**TOWN OF NEWBURGH
PLANNING BOARD
TECHNICAL REVIEW COMMENTS**

PROJECT NAME: O'REILLY AUTO PARTS
PROJECT NO.: 23-21
PROJECT LOCATION: SECTION 60, BLOCK 3, LOT 41.21
REVIEW DATE: 10 NOVEMBER 2023
MEETING DATE: 16 NOVEMBER 2023
PROJECT REPRESENTATIVE: KINETIC DESIGN AND DEVELOPMENT

TYPICAL PARKING SPACE DETAIL

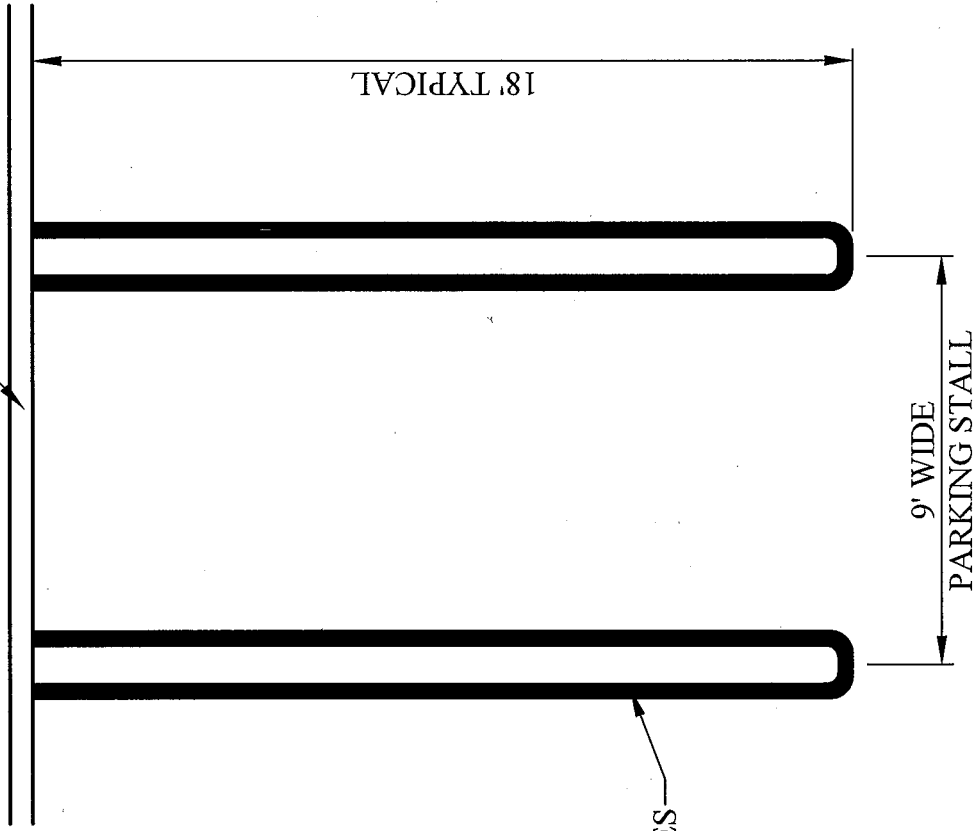
- New storefront and vestibule are proposed along the eastern access. Existing awnings are proposed to be removed.
 - All striping should be compliant with Town of Newburgh required details. Copy Attached.
